# **Product Change Notification**

Product	VL812 USB 3.0 Hub Controller								
Category		News		Errata		Report	•	Letter	
Description	Release Date		Jan18 <sup>th</sup> , 2013		Revision		1.2

# VL812 USB 3.0 Hub IC Revision Change (B1→B2)

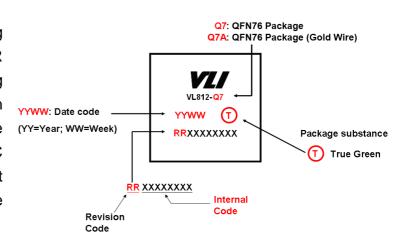
VLI VL812 Hub IC top-side marking displays a REVISION CODE in RR format on all IC versions including engineering and evaluation samples to mass production. The revision code denotes the IC REVISION. The previous product has a revision code of B1. The revised product uses B2.

PACKAGE : QFN 76 DATE CODE : YYWW
